**PR/0896/22**

## Record of Executive Business and Chief Executive's Order

**Reg. Reference:** SD21A/0329      **Application Date:** 01-Dec-2021  
**Submission Type:** Clarification of Additional Information      **Registration Date:** 21-Jun-2022

**Proposed Development:** Development comprising 189sq.m of warehouse space and 89sq.m of ancillary office space.

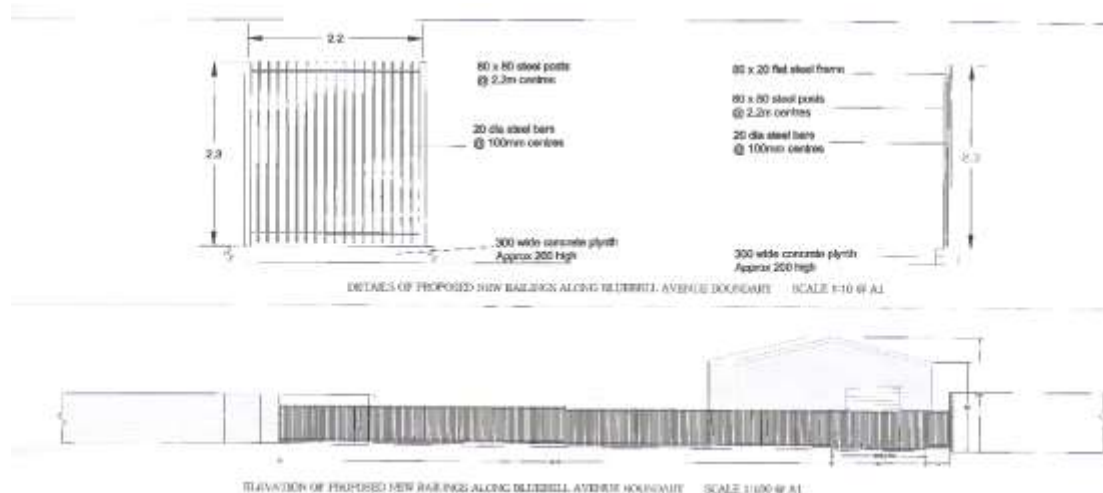
- 3. See drawing no ZF11/P04 for details of the proposed new railings along the Bluebell Avenue Boundary.**

A drawing showing the proposed railing boundary treatment (2.3m high set on top of a 200mm high concrete plinth) can be seen below and is considered to be satisfactory to the Planning Authority.

The Planning Authority Considers the applicant has satisfactorily addressed the request for Additional Information for this item.
